**THEME 3 - The processes for selection and refinement of the Inland Rail route
ANALYSIS OF THE FORESTRY ROUTE - BORDER TO GOWRIE - INLAND RAIL**

AN ANALYSIS of the COMPARATIVE REVIEW of the FORESTRY ROUTE OPTIONS FOR INLAND RAIL via CECIL PLAINS

Prepared by Kevin Loveday, [REDACTED]

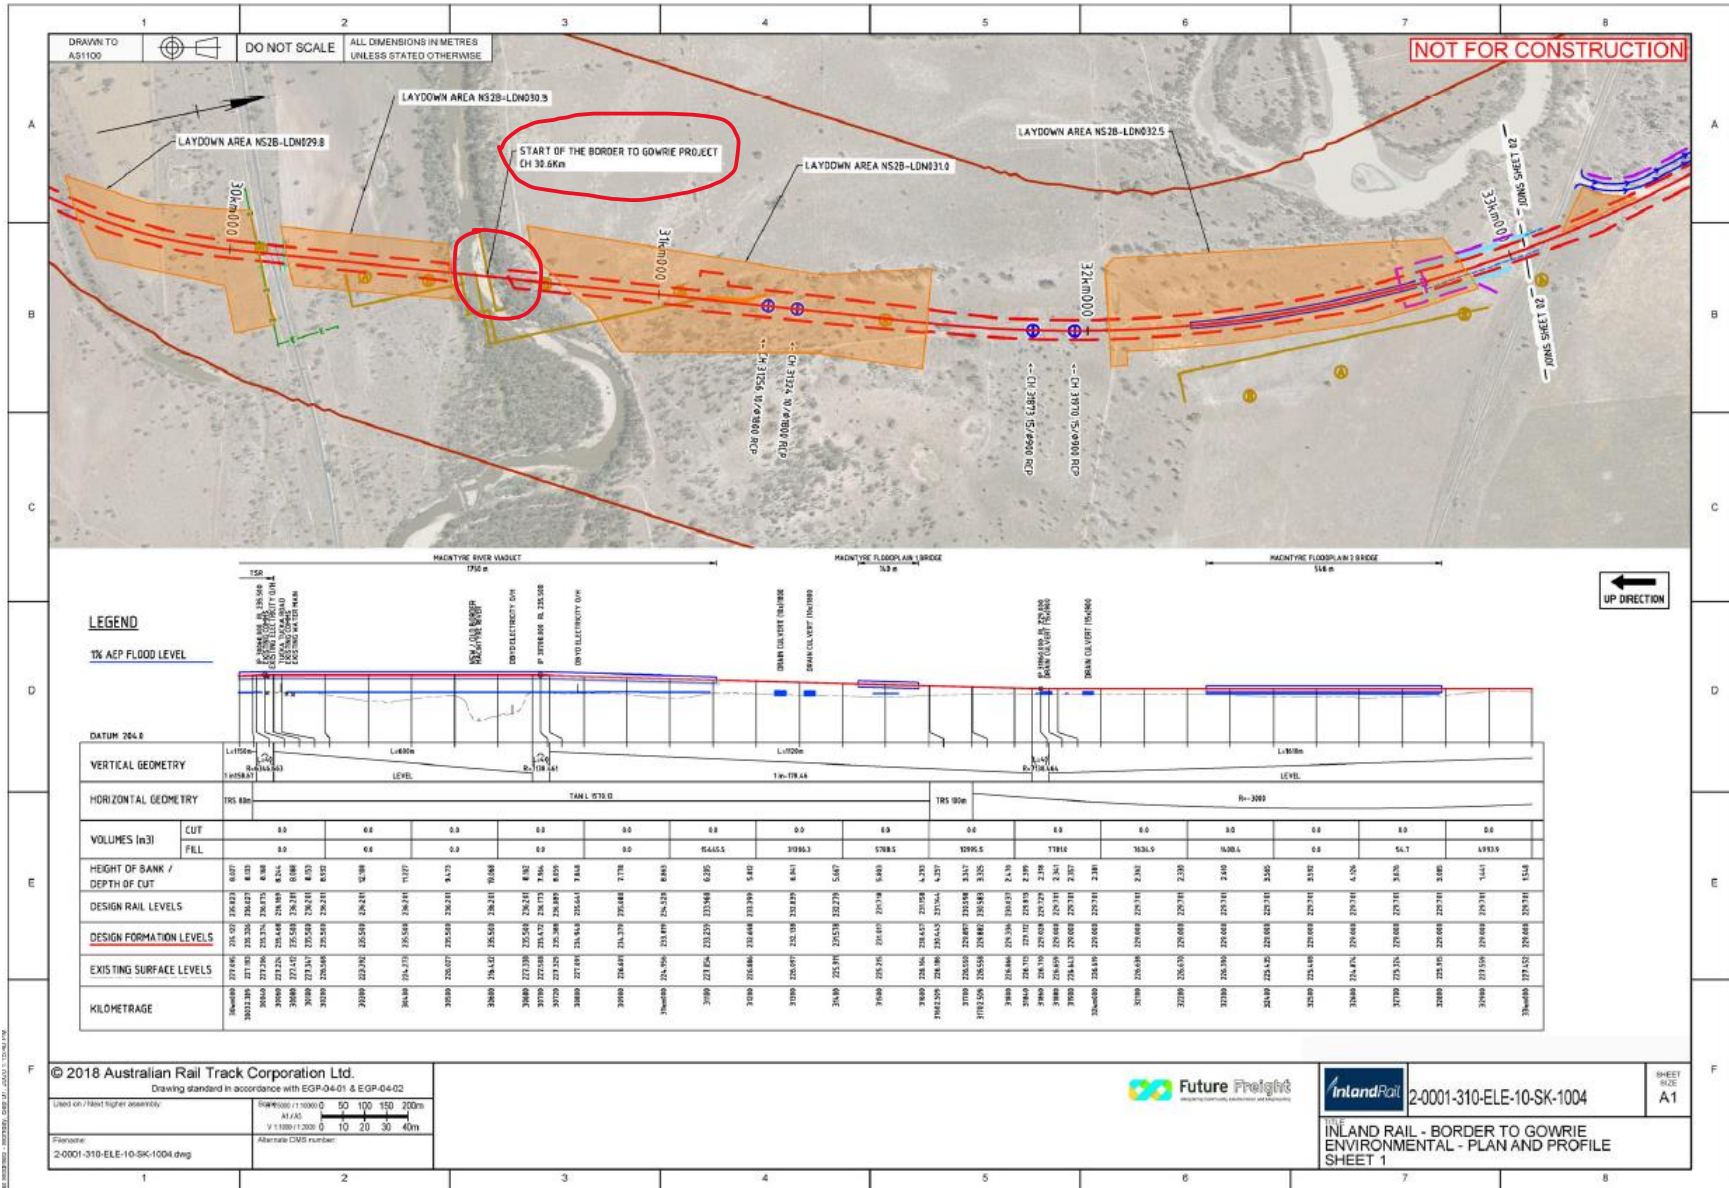
On page 7 - Chapter 2 APPROACH to this REVIEW Section 2.4, Table 2.3 summarises the basics of the different alignments (above). This table plainly states the LENGTH of each of the above options and clearly states that the Reference Design is **206.95 km** long. This essential data was supplied by ARTC in Appendix A (the ARTC Information Paper) which also states that the length is **206.9 km**.

However, in the **EIS of B2G**, ARTC have repeatedly stated many times that the length of the Reference Design is actually **216.2 km**. Chapter 5.5 of the B2G E.I.S. (Project Description) states that "*The Project is a 216.2 km section ... between the NSW/Qld border and Gowrie*" and goes on to state that "*The Project commences at Chainage 30.6 km North Star to Border (NS2B)section at the NSW/Qld border - the medium point at the Macintyre River*". EIS Appendix ZZ, Sheet 1 confirms this by a clear notation indicating the start point of B2G.

However, the Chainage for the B2G does **not** start at this point on the river, as would be expected. The NS2B Chainage continues on into Queensland to finish at **39.85 km and this is where the B2G Chainage commences**. This is shown on Sheet 4 of EIS Appendix ZZ .

It is, indeed, difficult to understand just why the B2G chainage does NOT start at Chainage 30.6km where the NS2B section ends.

The fact is that there is a **9.25 km (39.85 - 30.6 km)** stretch of B2G route that is **NOT included** in ARTC's stated length of B2G Reference Design.

Map D3: Forestry route via Cecil Plains – 1% AEP flood flux

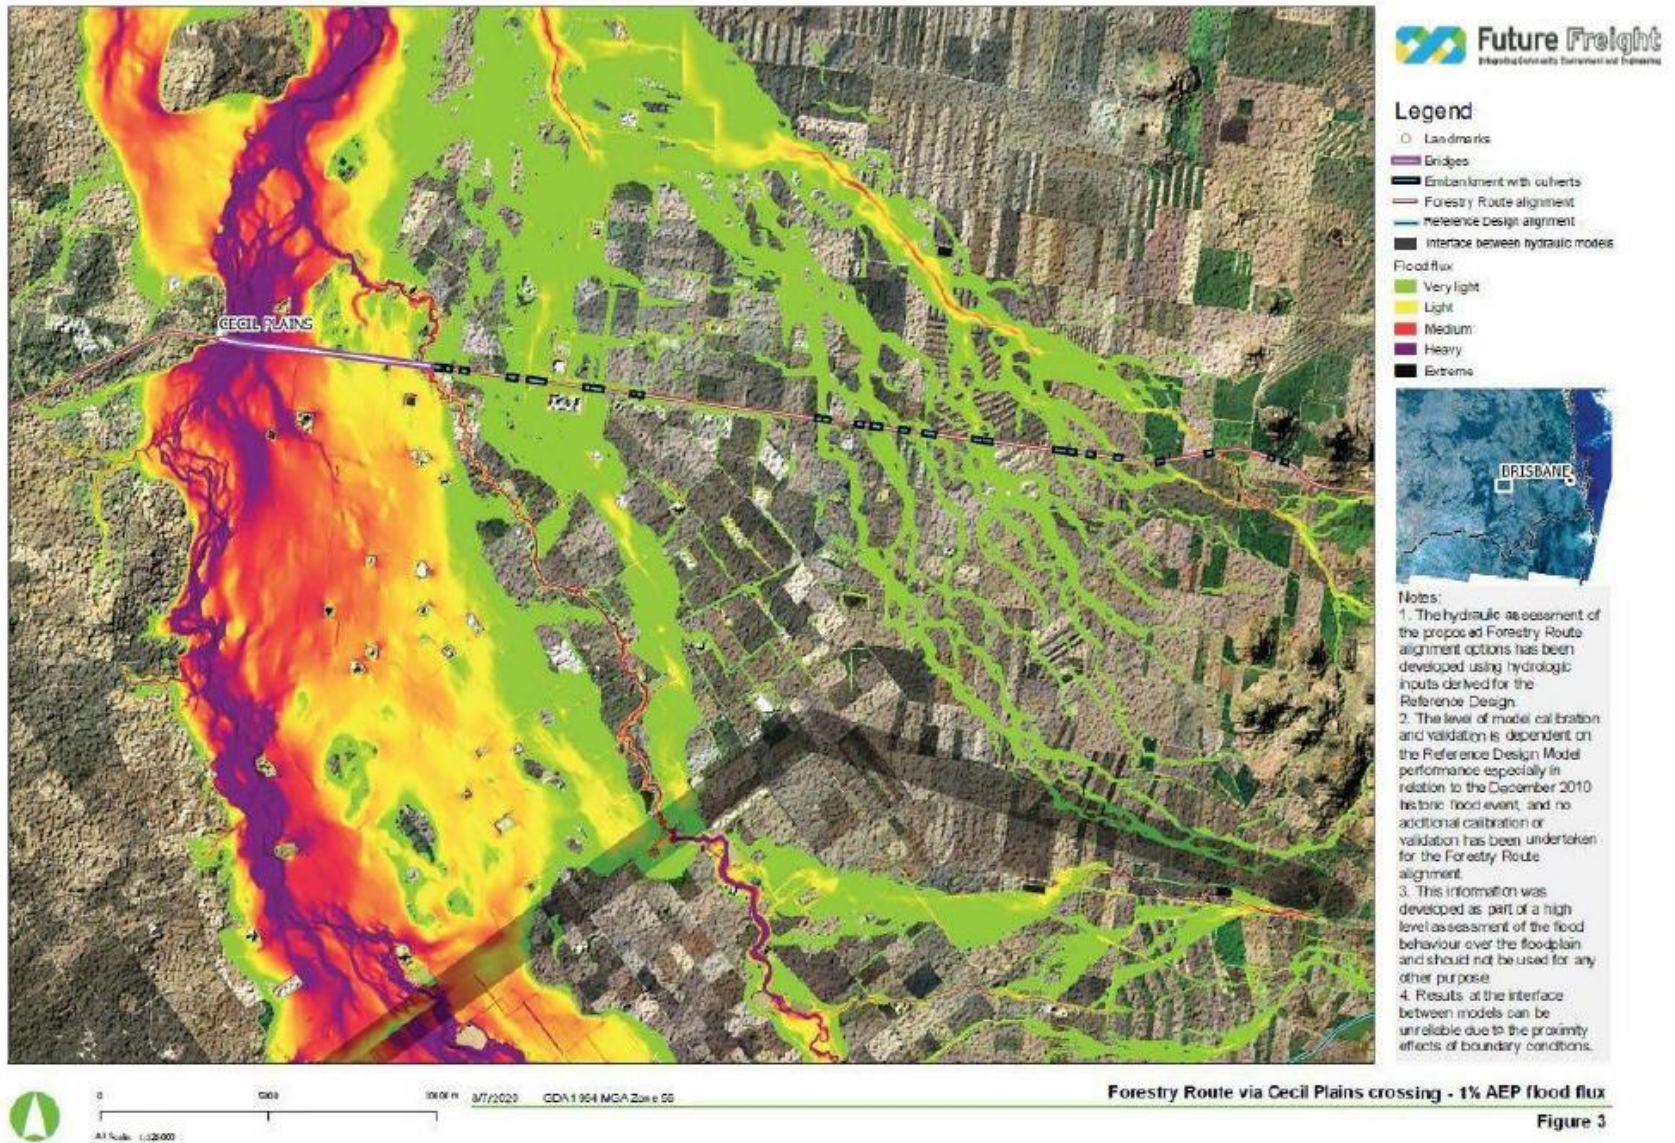
Table 7.1 (page 21) states that ARTC have determined that a 6.3 km viaduct across the floodplain is required. Whilst acknowledging that viaducts will be necessary across both the main stream of the Condamine River and the North Branch, it is difficult to see why a continuous 6.3 km viaduct from Cecil Plains to the east side of the North Branch is essential - particularly in view of the fact that approximately 1 km of that distance is flood free at Horraine.

Why not 2 viaducts - one from Cecil Plains east for 3.1 km and another of 2.0 km over the North Branch? This proposal would bridge ALL the areas of potential heavy and medium flood flux as well as the 2 km area of light flood flux west of the North Branch and would save over a kilometre of unnecessary bridging cost impacting on the comparative costing of the Cecil Plains routes.

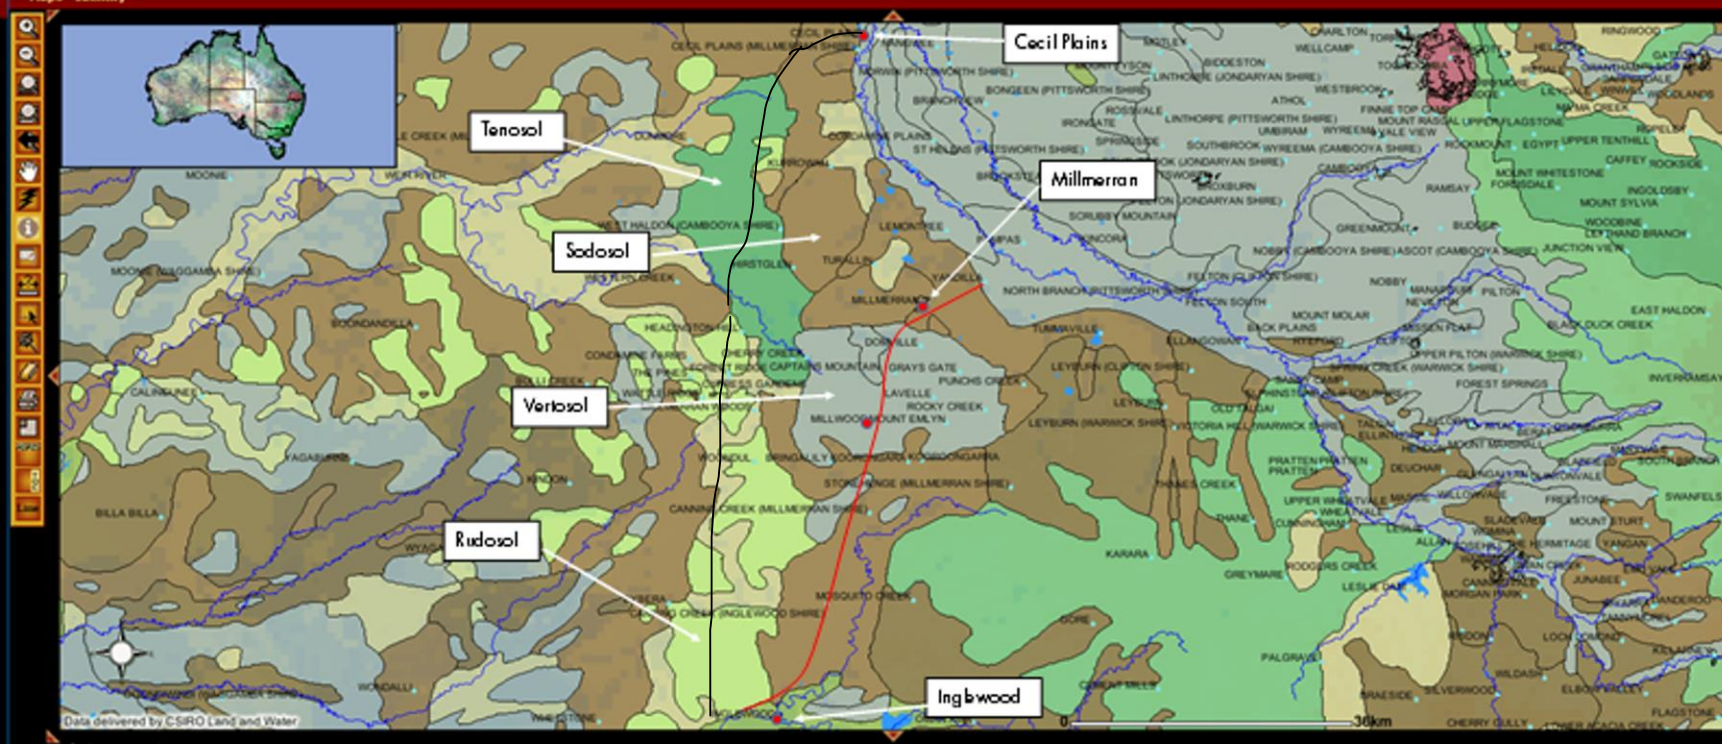
The Reference Route, on the other hand, in the 75 km between Inglewood and Yandilla, traverses mainly SODOSOL and VERTOSOL soils. Their description is: -

- C. SODOSOL soils - Duplex soils with sandy or loam A horizon overlaying a B horizon of sodic (dispersive, unstable) clay (very risky for foundation material due to high risk of tunnel erosion).
- D. VERTOSOL soils - Cracking clays (fertile, highly erodible, poor foundations).

The soil type descriptions (above) clearly demonstrate the fundamental difference between the 2 different route alignments. The Cecil Plains routes follow country which is eminently suitable for heavy rail construction at base cost. The need for foundation excavation and fill with suitable material will be consequently eliminated as the soil itself lends itself to actual foundation usage.

The Reference Route, on the other hand, traverses land which is clearly unsuitable for the foundations for this rail track. Land along this corridor will have to be excavated to suitable depth and then filled and compacted with "bought-in" fill - just to have a stable base for the foundation, ballast, and track. The cost and logistic issues will be comprehensive. Where to stockpile and eventually dispose of the excavated material? Where to source suitable, compliant fill and how far to carry this fill to the required site? Where to source adequate and suitable water to properly compact the fill?
